City of Portland, Maine - Building or Use Permit Application

Location of Construction: 147 Milton St	Owner Name: Amabile Nicholas	Owner Address: 4 Dover St	Phone: 878-0233
Business Name: n/a	Contractor Name: Glennie, Mark	Contractor Address: 516 Cape Rd. Standish	Phone: 2076424596
Lessee/Buyer's Name: n/a	Phone: n/a	Permit Type: Additions - Dwellings	Zone:

BUILDING PERMIT REPORT

REASON FOR PERMIT: To Construct a 12'x12' addition -

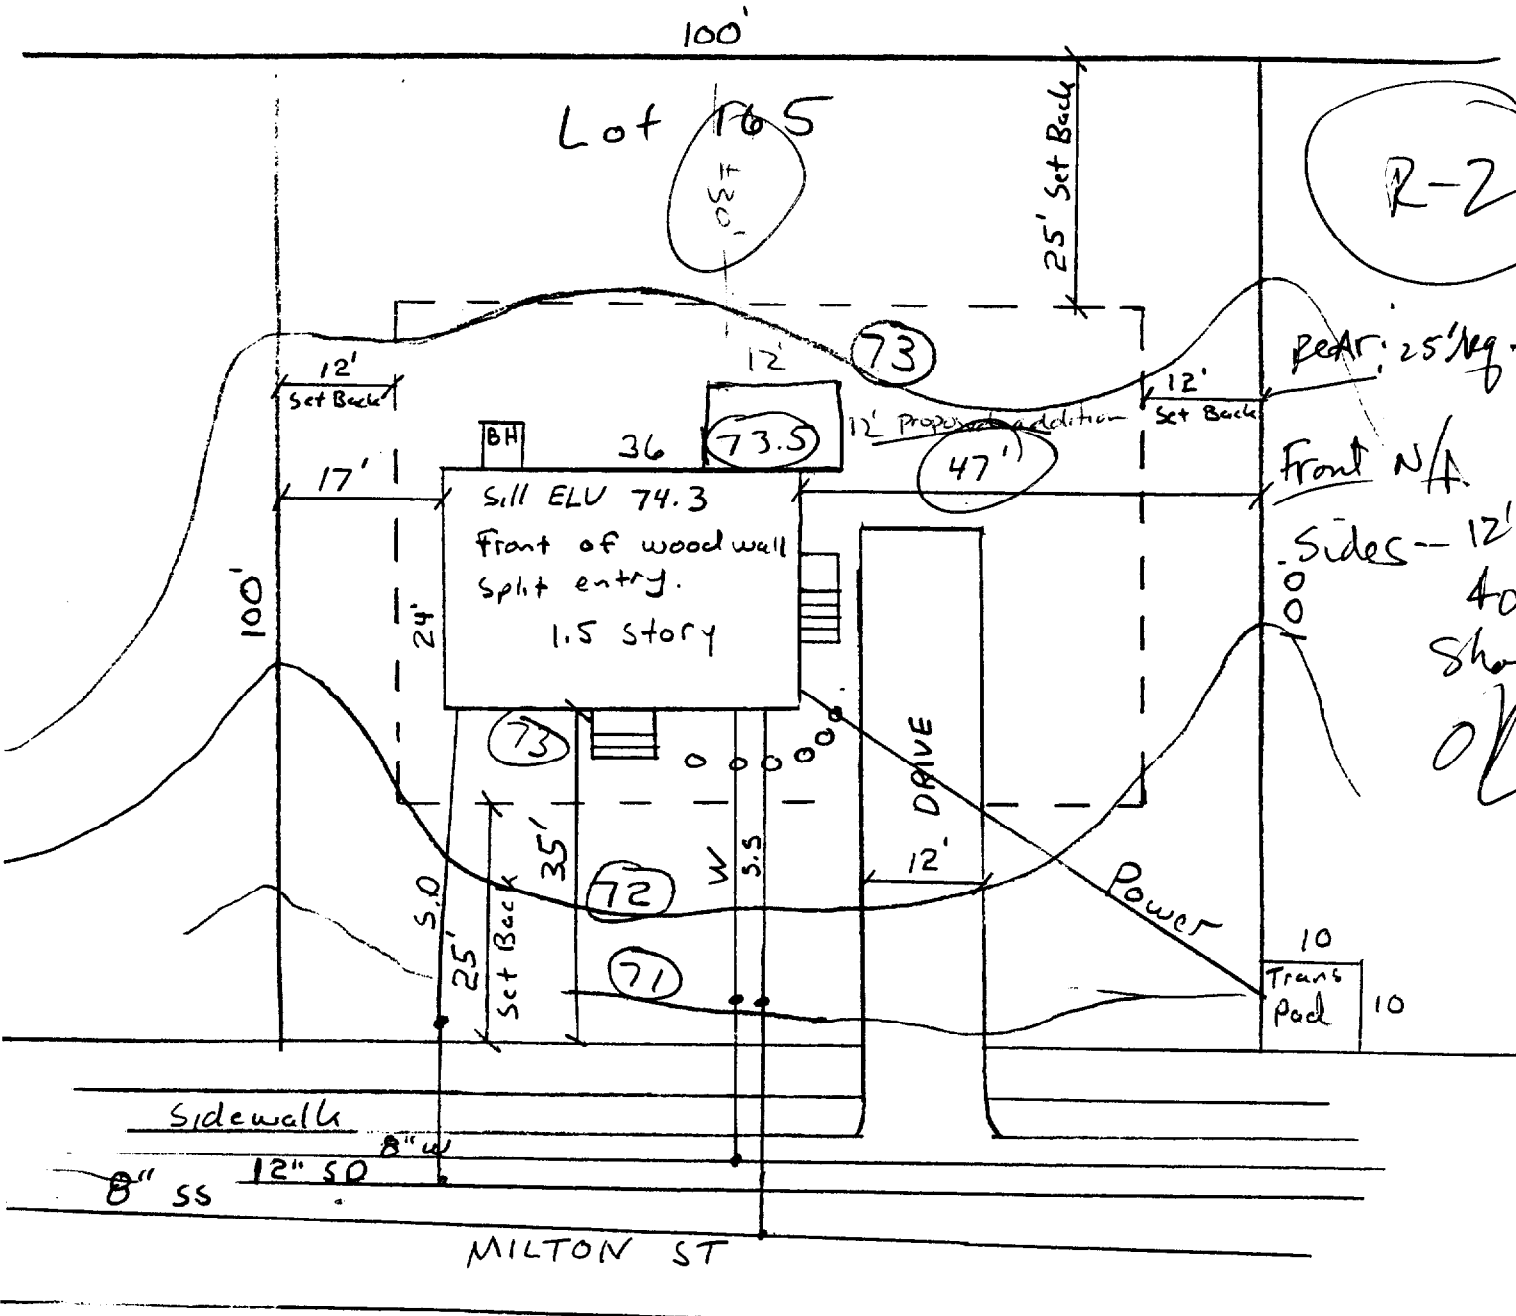
Rear: 25' req - 30' shown

Sides - 12' req  
40' shown  
OK

CROSS SECTION

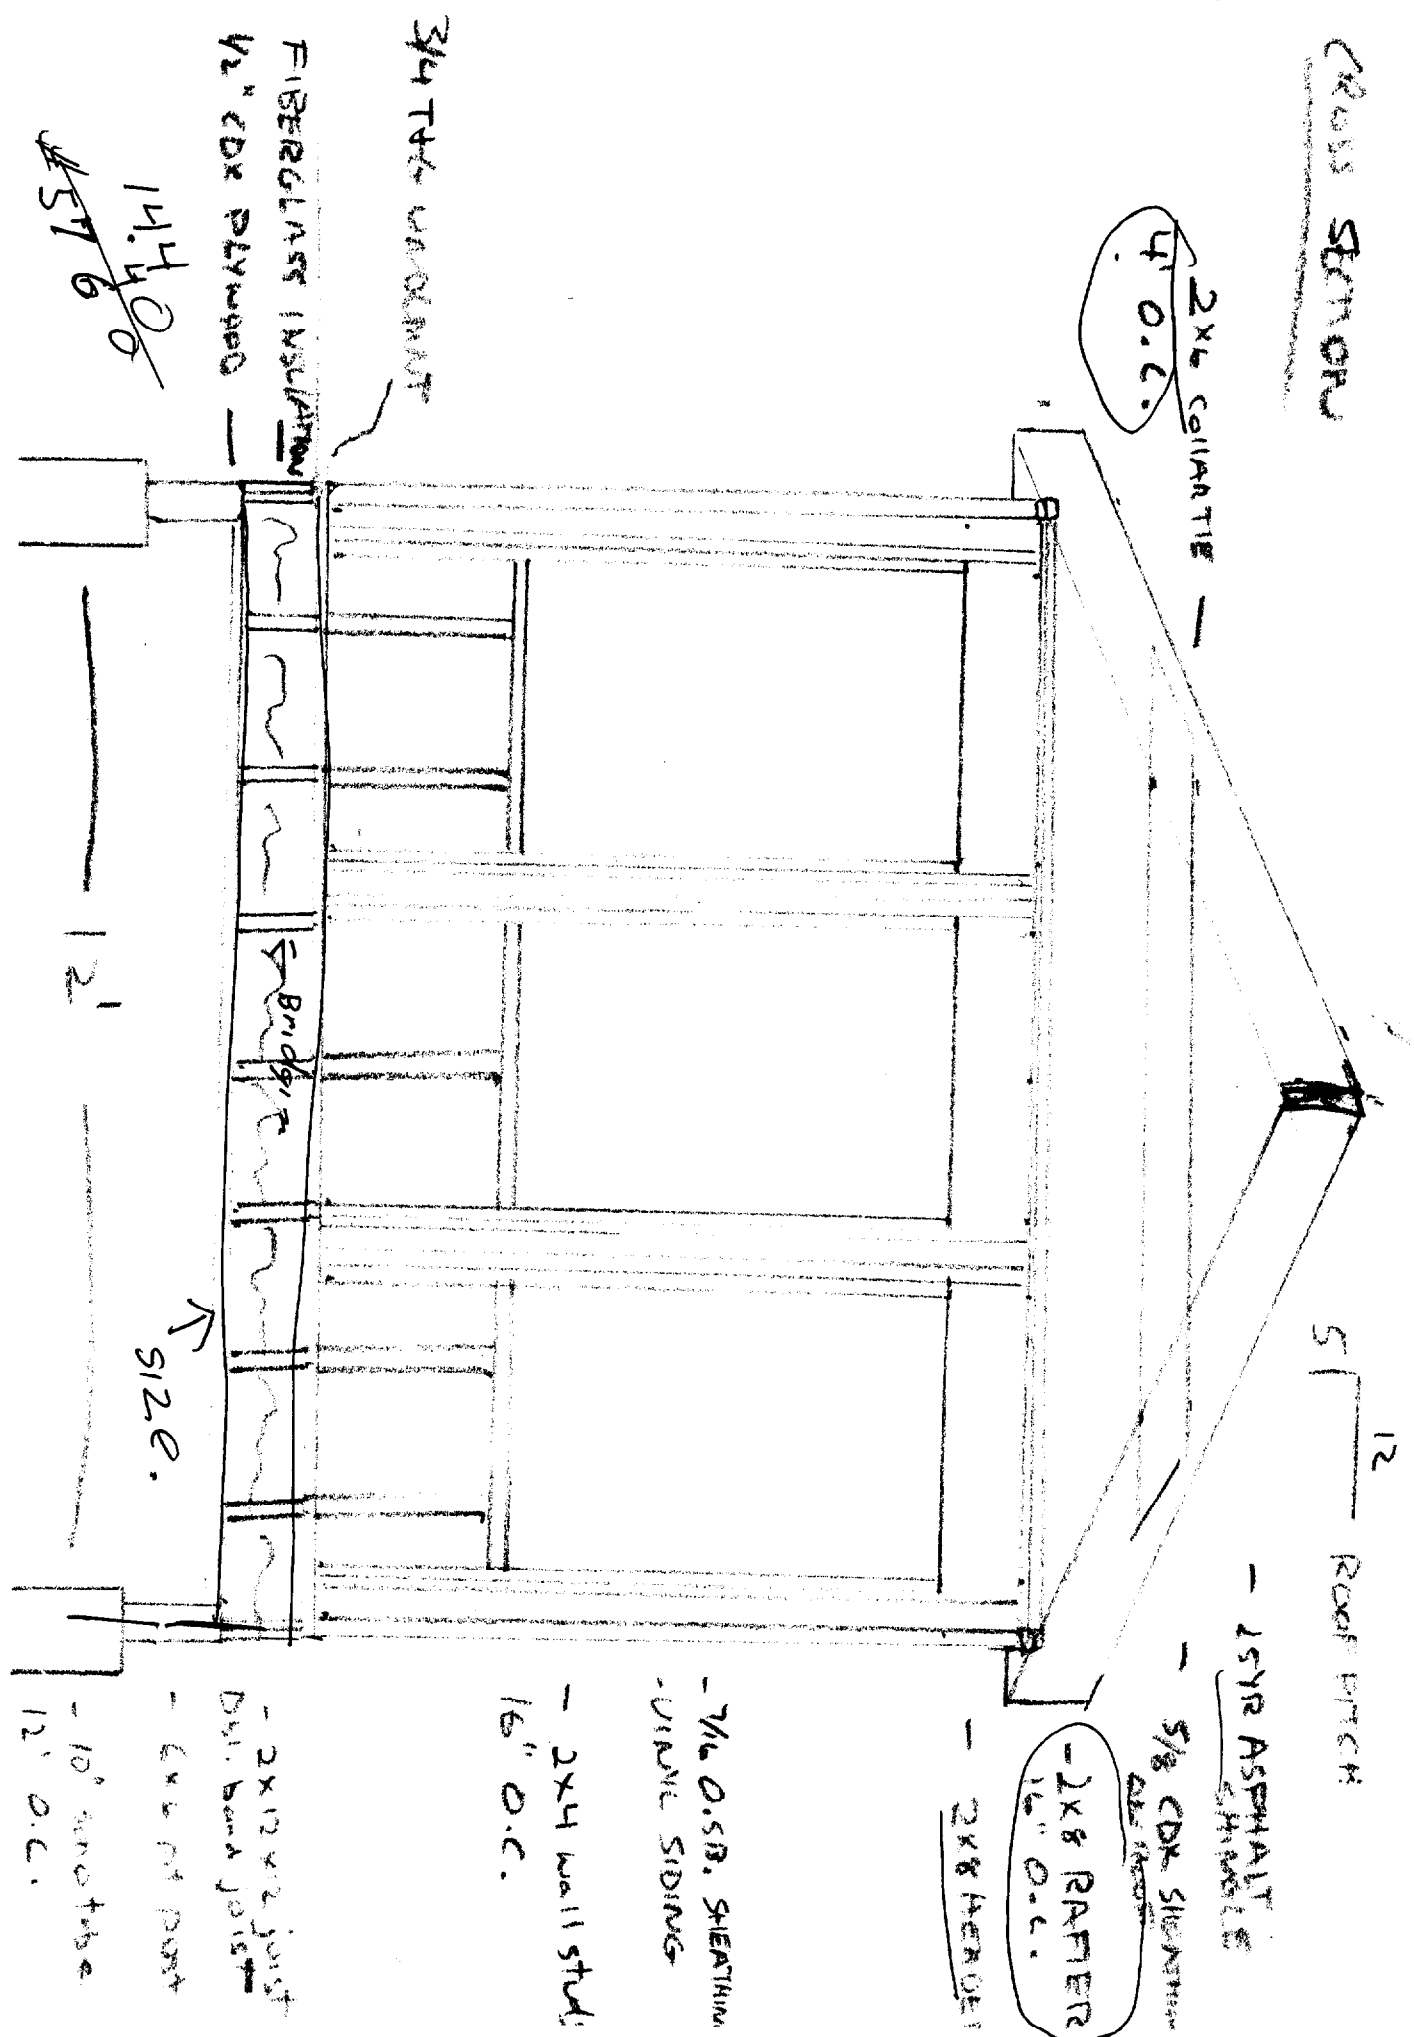
- \*38. *Archers shall be used between piers and column, column and framing of structure*
